TECHNICAL BULLETIN

GOT-A-0230-B

Change of the OS installed on MELIPC MI3000

2 Details of the change

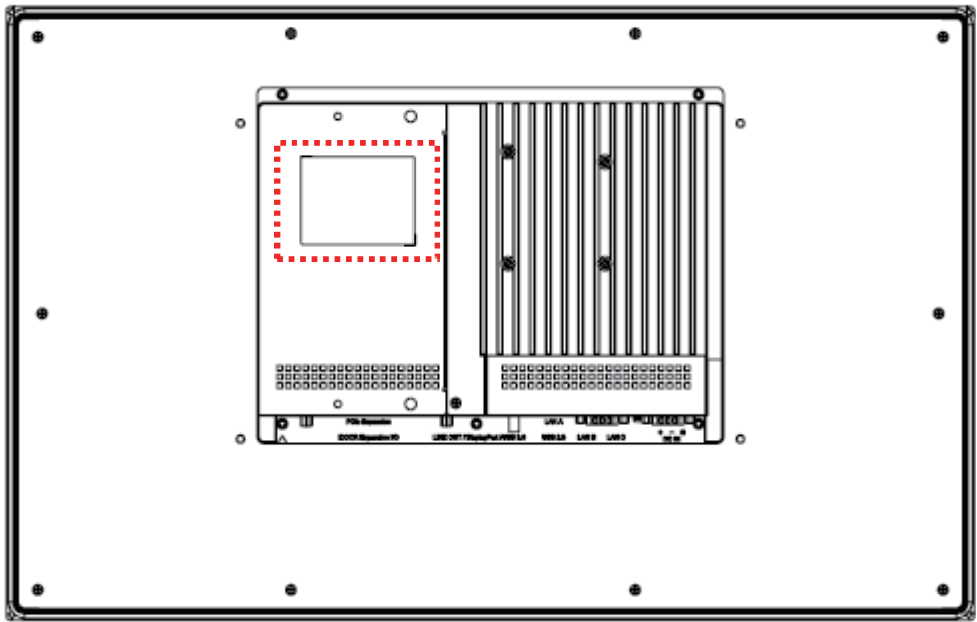
The OS installed on MI3000 will be changed to Microsoft Windows 10 IoT Enterprise 2021 LTSC.

Product	Model	Before	After
MELIPC MI3000	MI3321G-W	Microsoft Windows 10 IoT Enterprise 2016 LTSC	Microsoft Windows 10 IoT Enterprise 2021 LTSC
	MI3315G-W
